Record of Decision
Photocircuits Corporation
Operable Unit No. 1
City of Glen Cove, Nassau County, New York
Site Number 130009

March 2008

DECLARATION STATEMENT - RECORD OF DECISION

Figure 3 - RI Groundwater Sampling

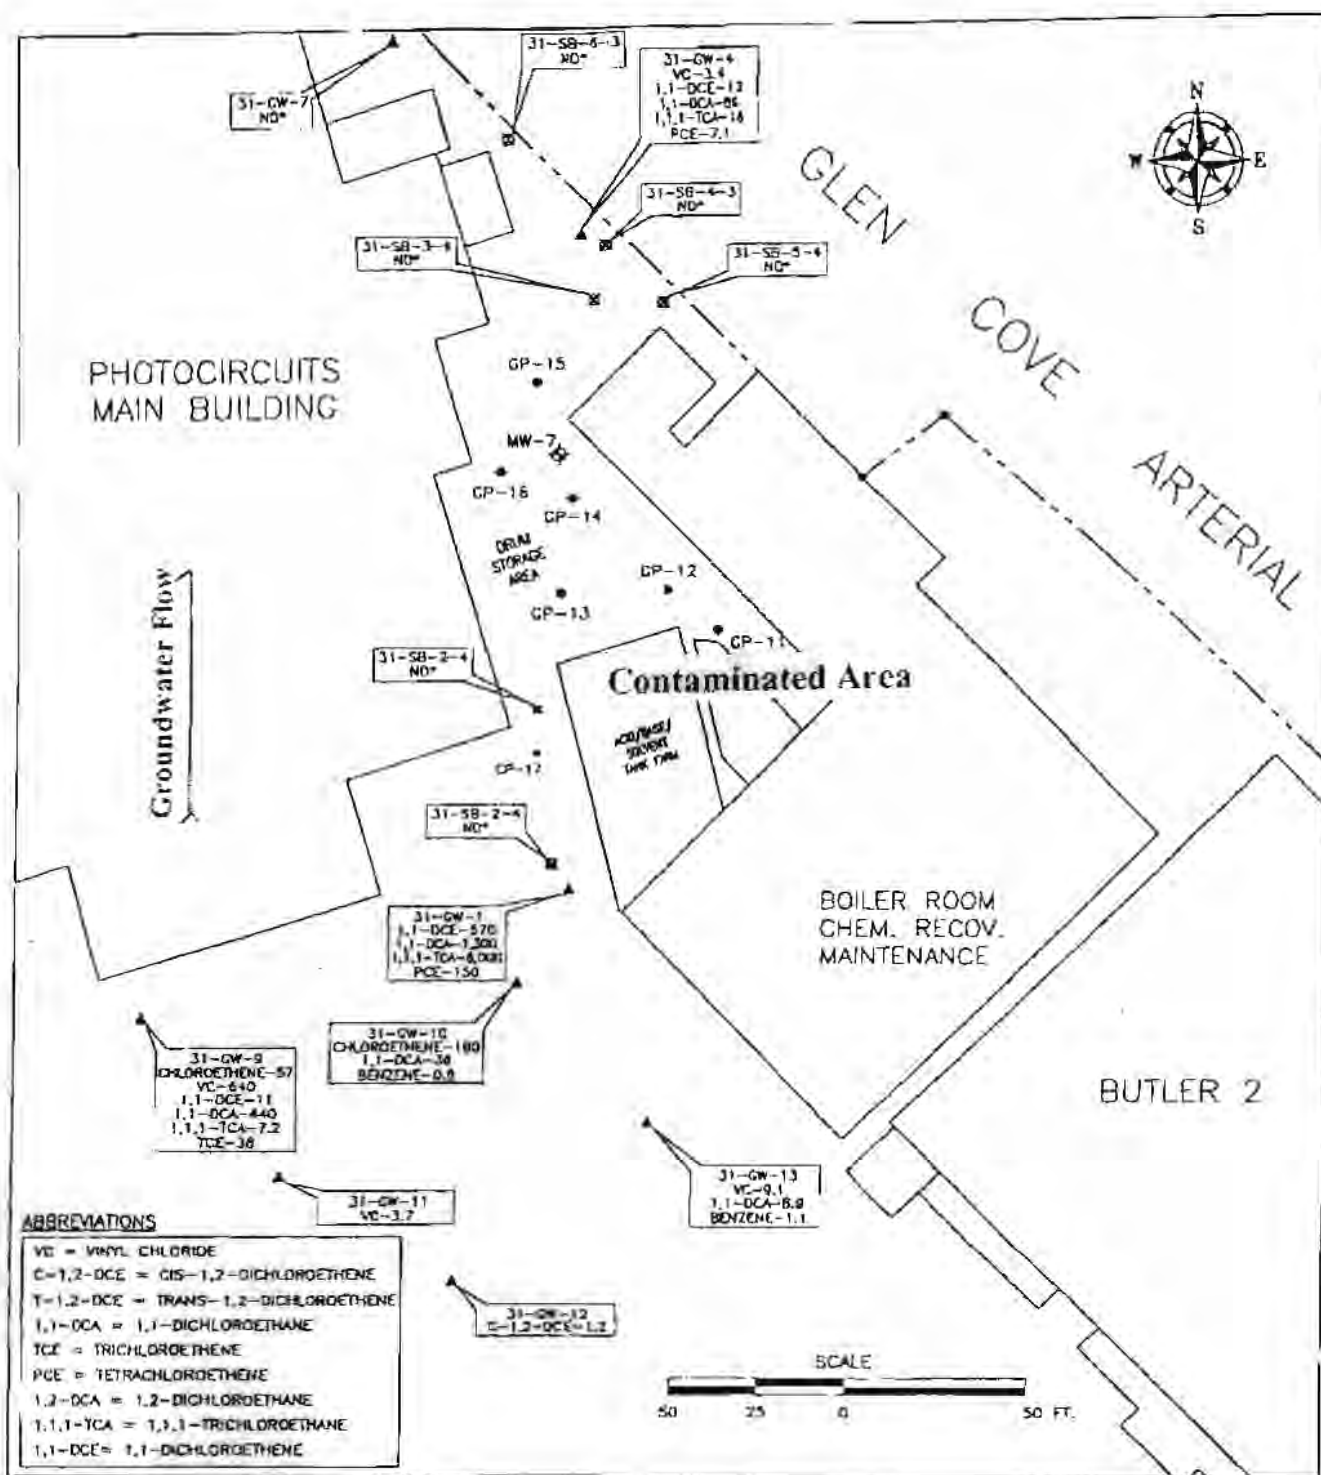
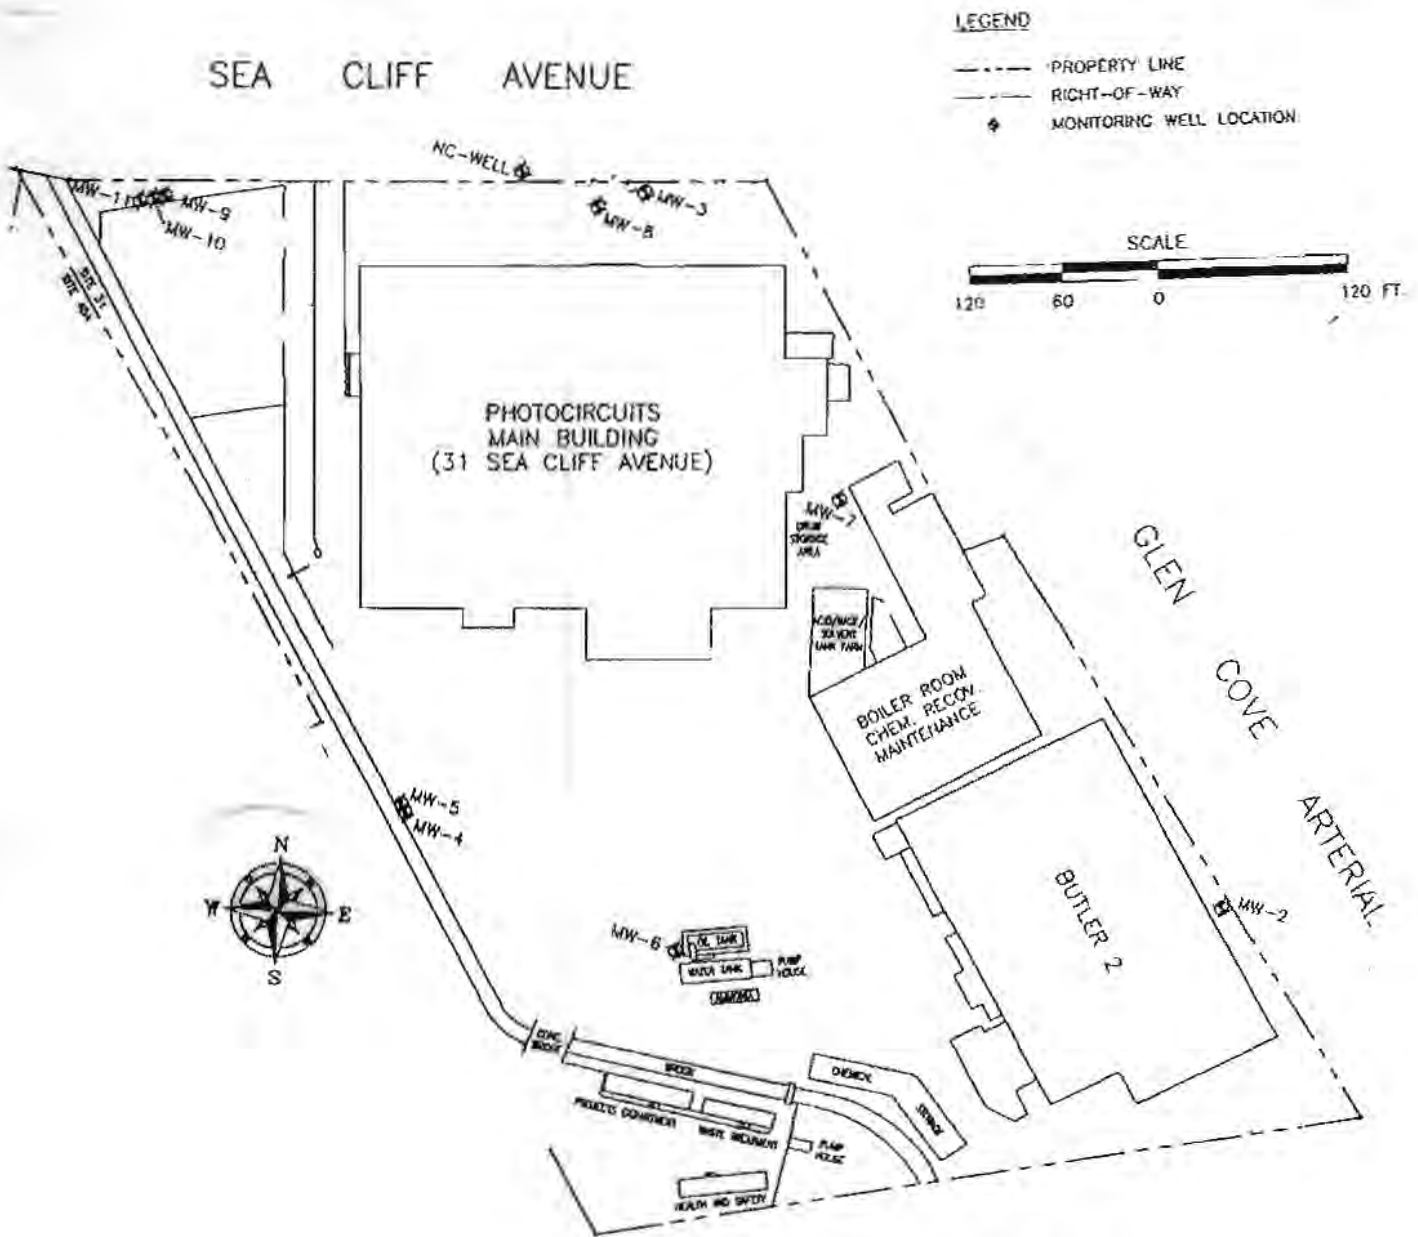
COMMENT 34: Comment 5: P. 4, Para 2, Line 2: A comparison of Figures 2 and 3 indicate that much of the Photocircuits property, including the entire area near Butler 2 was never investigated. This would result from the fact that only a Focused Remedial Investigation was performed. The NYSDEC should include data for other areas of the site, if any exist. If no additional data exist, additional investigation - including sampling within the building footprint underlying

RESPONSE 34: Investigations performed prior to the FRI include the "Source Area Investigation for the Sea Cliff Industrial Area" performed in 1992, and the "Preliminary Site Investigation" performed in 1996, both cited in the PRAP. These reports identified the drum storage and tank farm areas located to the east of the Photocircuits' main building as the primary areas of concern at the site. Inclusion of the data from these investigations is beyond the scope of a PRAP, however, both documents are available in the repositories.
